SUBJECT: Second Ten Year Inservice Inspection Program

Byron Nuclear Power Station, Units 1 and 2
Facility Operating Licenses NPF-37 and NPF-66
NRC Docket Nos. 50-454 and 50-455

ATTACHMENT 1
RAI QUESTIONS AND RESPONSES

ATTACHMENT 3
REVISED RELIEF REQUESTS

FIGURE 1

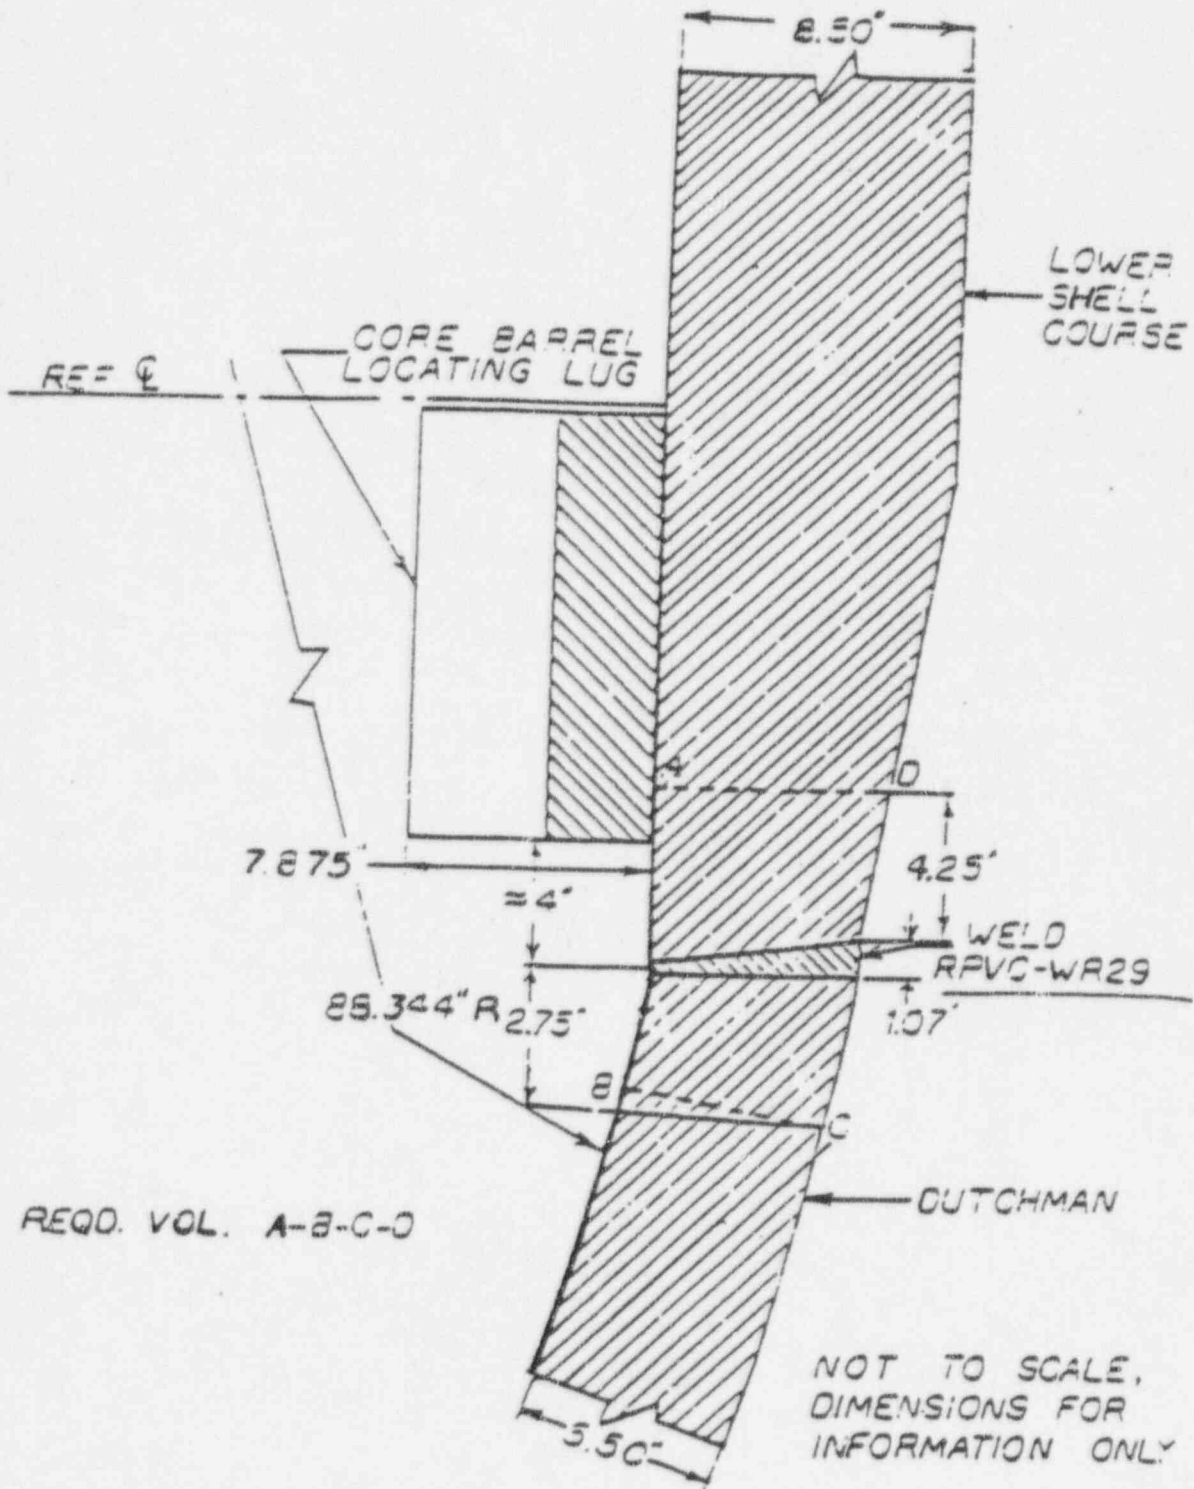
The examination of the Unit 1 Lower Shell Course-to-Dutchman weld, RPVC-WR29, is restricted by six (6) core barrel locating lugs welded to the inner surface of the vessel approximately 4 inches above the weld (See Figure 1).

These lugs obstruct the automated UT inspection tool from examining the code required volume of the weld below each lug (156°). The FTI "URSULA" tool has a 6 degree movement arm and the physical size of the lugs and the "yaw" joint of the tool prevented scanning below the lugs back into the weld and surrounding base metal. All weld metal can be examined from both sides where access is available between the lugs (204°). Examinations for perpendicular and parallel reflectors covered areas accounting for 57% of the weld metal and heat affected zone (HAZ). Similarly, 57% of the weld metal can be examined for transverse reflectors from two opposing directions.

The examination of the Unit 2 Lower Shell Course-to-Dutchman weld, RPVC-WR29, is similarly obstructed (see Figure 1). All weld metal can be examined from both sides where access is available between the lugs (204°). Examinations for perpendicular and parallel reflectors can cover areas accounting for 57% of the weld metal and heat affected zone (HAZ). Similarly, 57% of the weld metal can be examined for transverse reflectors from two opposing directions.

FIGURE 2

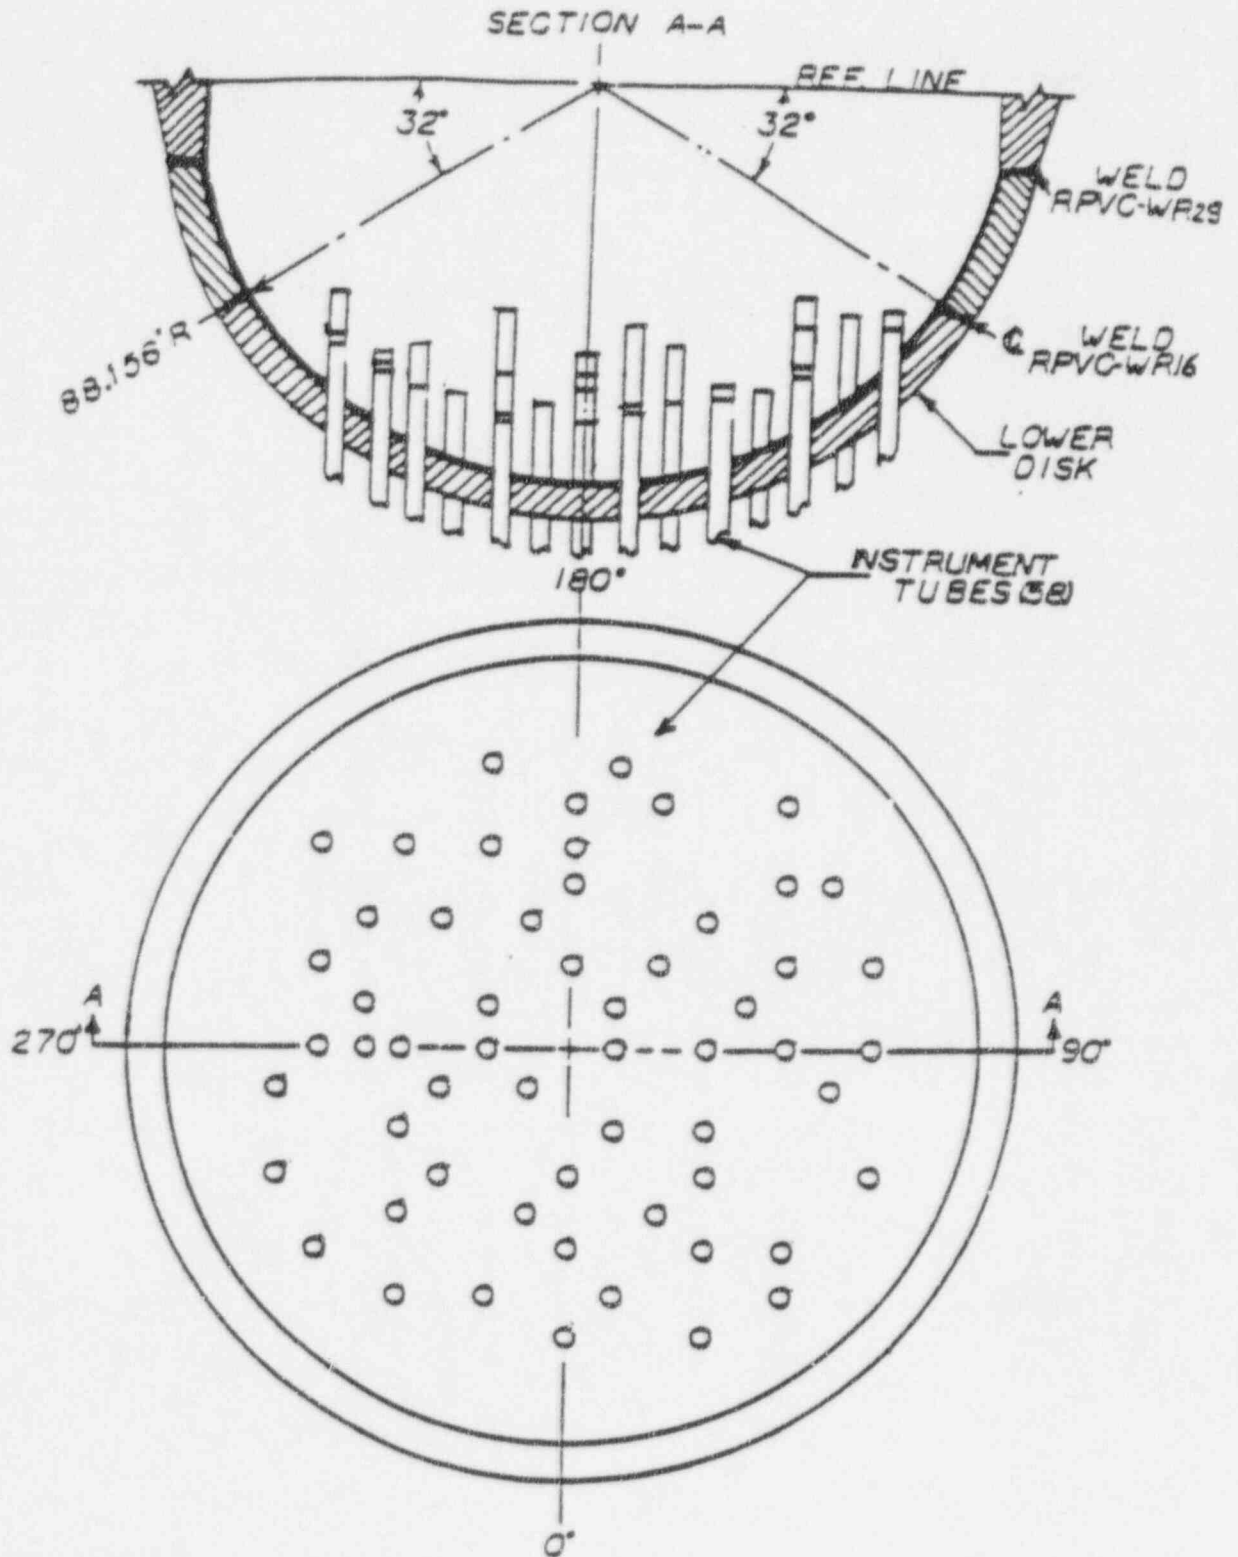
The examination of the Unit 1 Lower Disk-to-Dutchman weld, RPVC-WR16, is restricted by the 58 instrument tubes that penetrate the lower disk and physically obstruct the UT search unit and/or the search unit position device as shown in Figure 2 and 3. Approximately 19% of the weld length cannot be examined. The weld and the HAZ received essentially 100% coverage for parallel reflectors from the Dutchman side and for transverse reflectors in two opposing directions. Partial coverage is achieved for parallel reflectors from the disk side on the remainder of the weld resulting in an aggregate of all scan coverage of approximately 81%.

The examination of the Unit 2 Lower Disk-to-Dutchman weld, RPVC-WR16, is similarly restricted, see Figure 2 and 3. The weld and the HAZ will receive essentially 100% coverage for parallel reflectors from the Dutchman side and for transverse reflectors in two opposing directions. Partial coverage can be achieved for parallel reflectors from the disk side on the remainder of the weld resulting in an aggregate of all scan coverage of approximately 81%.

FIGURE 3

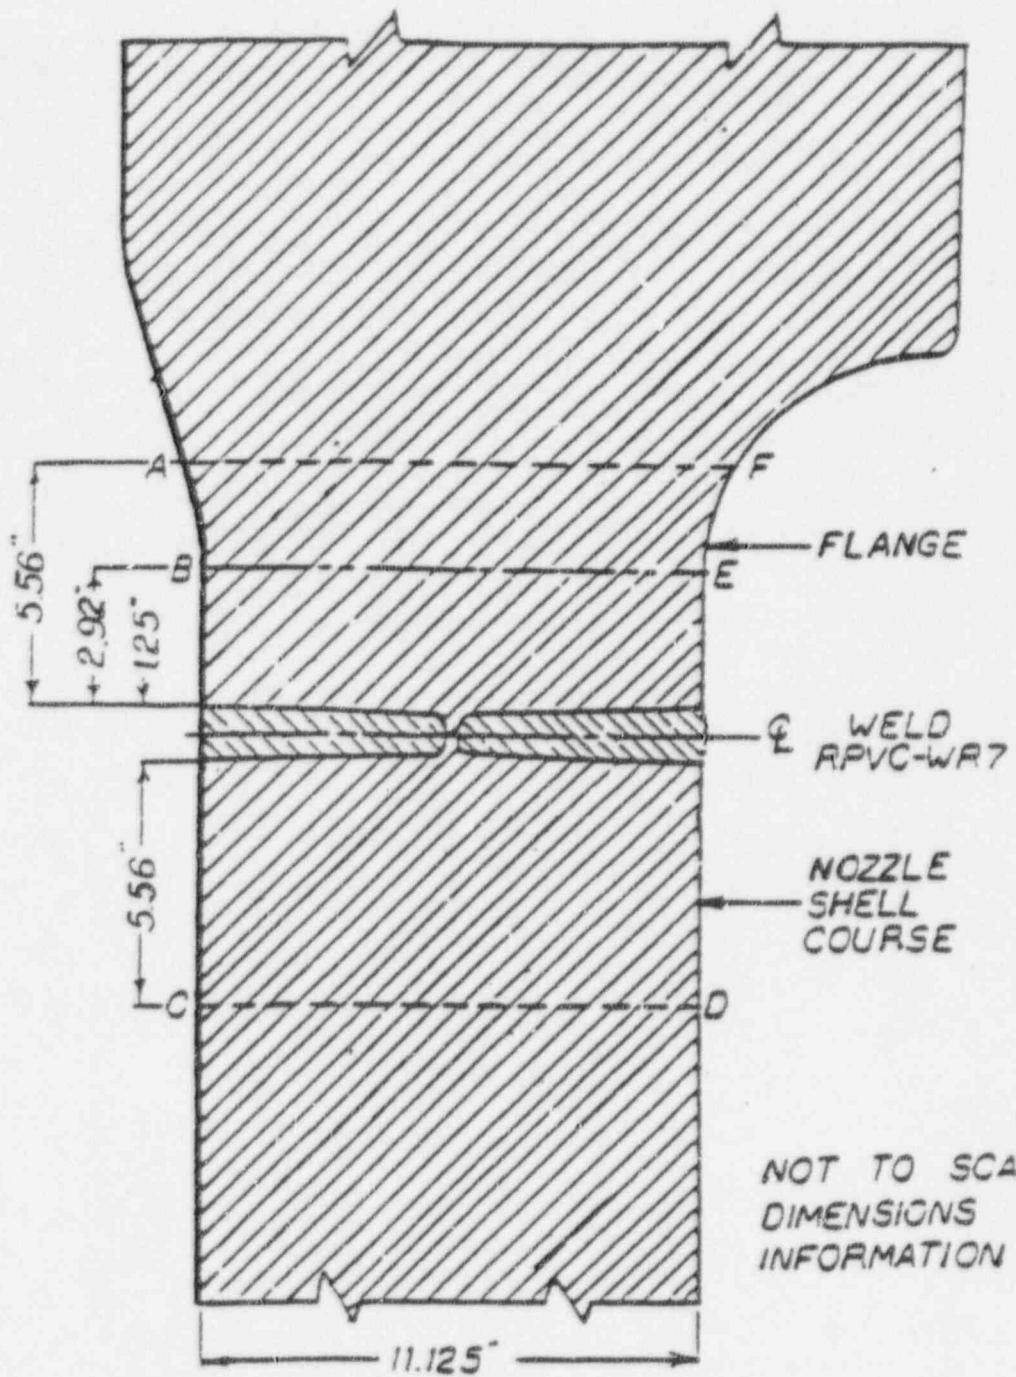
REQUIRED VOLUME A-C-D-F
VOLUME MISSED A-B-E-F

Figure 1

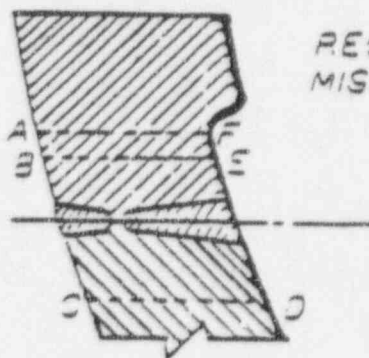
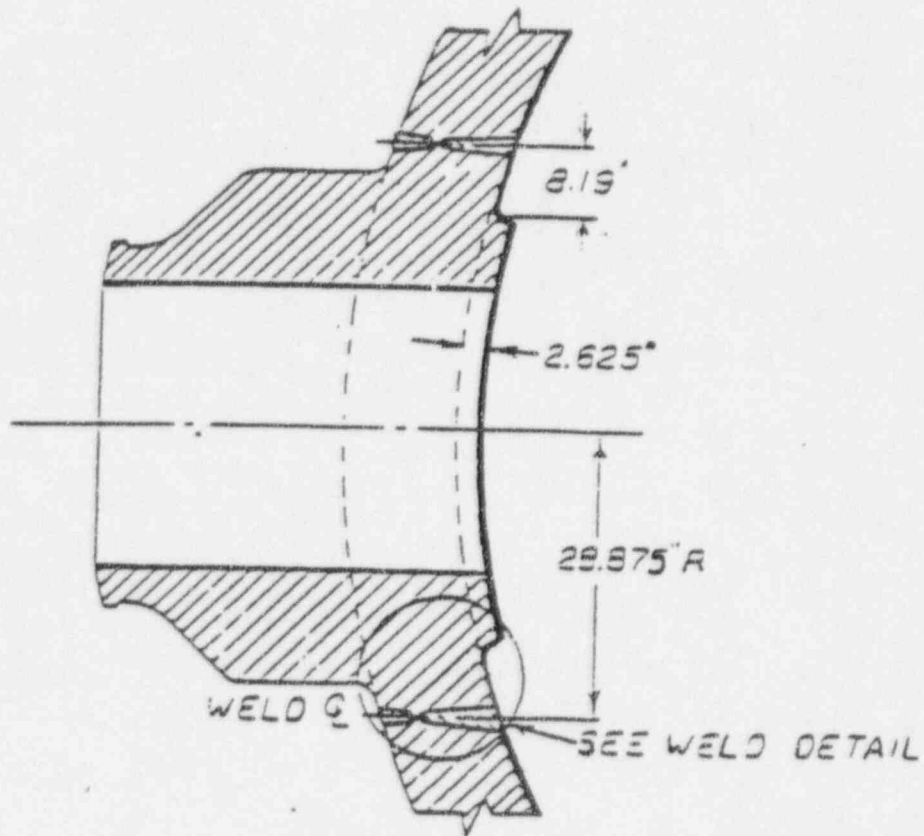
The Reactor Vessel Outlet Nozzles were designed and fabricated with an extension lip as shown in Figure 1 such that the nozzle-to-vessel welds are partially obstructed for the code required volumetric examination. This obstruction limits the circumferential scan for reflectors transverse to the weld such that 19% (aggregate) of the required volume can not be examined.

FIGURE 1:
Pressurizer Lower Head Assembly

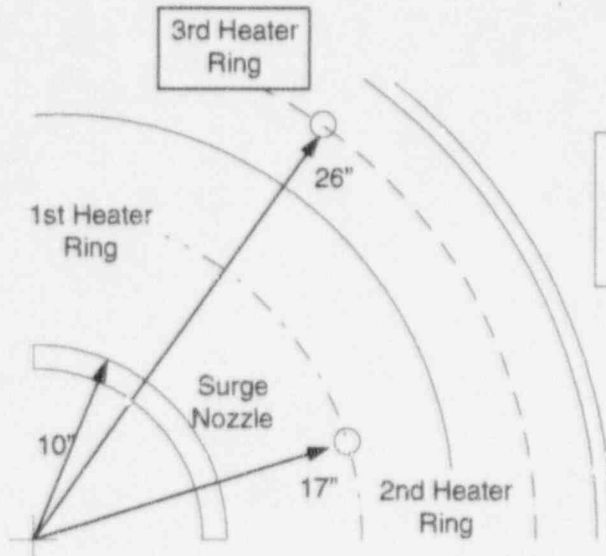
The Byron Unit 1 and 2 Pressurizers include a single surge nozzle which is welded to the lower head as shown in Figure 1. In order to perform the code required volumetric examinations on the nozzle-to-vessel weld and the nozzle inside radius section, the outer surface of the lower vessel head must be accessible for proper surface preparation and ultrasonic scanning.

FIGURE 2:
Vessel Centerline Distance to
Surge Nozzle and
Heater Elements

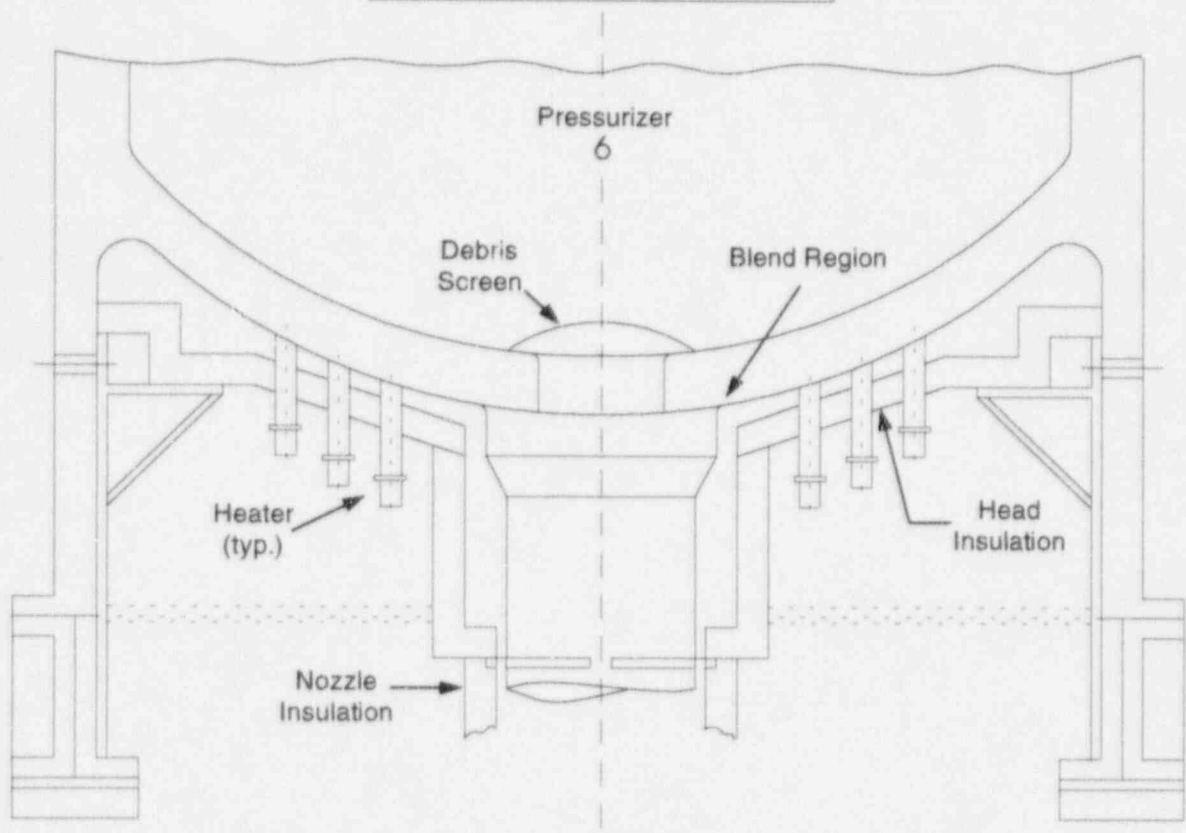
The lower head is normally covered by a 4 inch thick, multi-layered stainless steel insulation which was not designed for removal. In order to remove the insulation, the 78 heater penetration cables shown in Figure 2 would have to be disconnected. In addition, each of the 78 convection stops, which are riveted to the insulation would have to be cut to facilitate the insulation removal per Figure 3.

FIGURE 1:
RHR Vessel/Nozzle Configuration

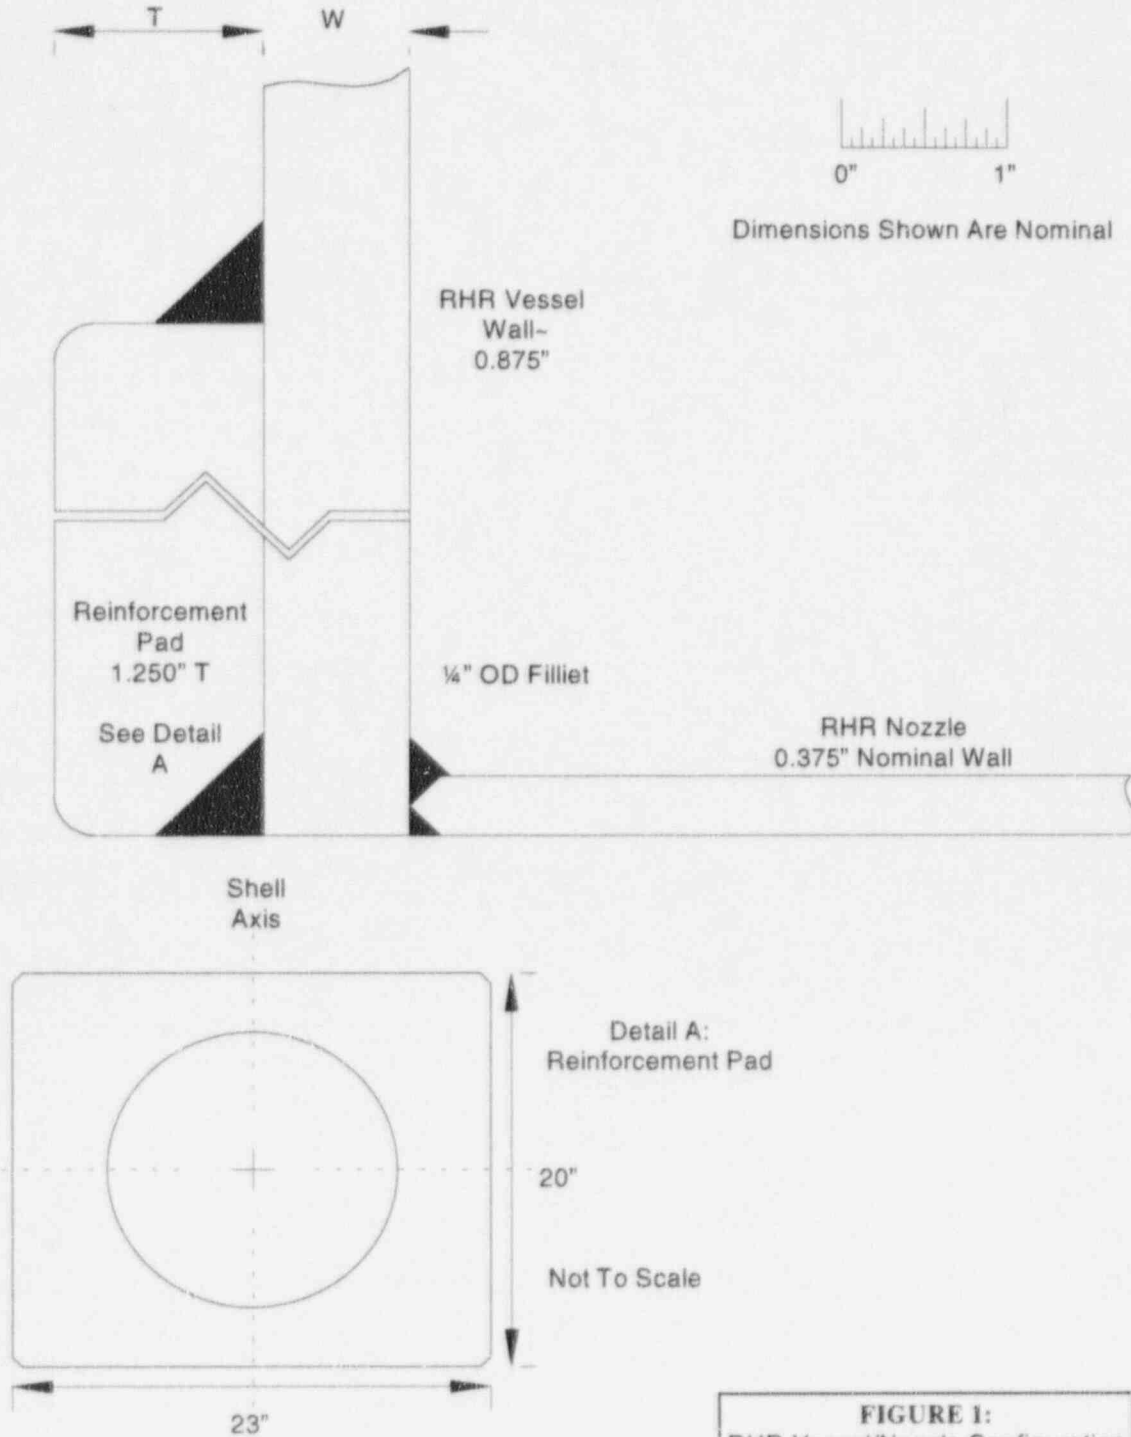
The Residual Heat Removal Heat Exchangers were fabricated with a nominal wall thickness of .875 inch and 14 inch diameter inlet and outlet nozzles which are .375 nominal wall thickness. As shown in Figure 1, the subject configuration is best characterized as a fillet welded nozzle with an internal reinforcement pad. The configuration is similar to that shown in Figure IWC-2500-4(c), except for internal location of the reinforcing pad. Because the inlet and outlet piping is welded to the subject nozzles, the inside of the RHR Heat Exchangers is not accessible as described in the "Parts Examined" text for Item No. C2.32.
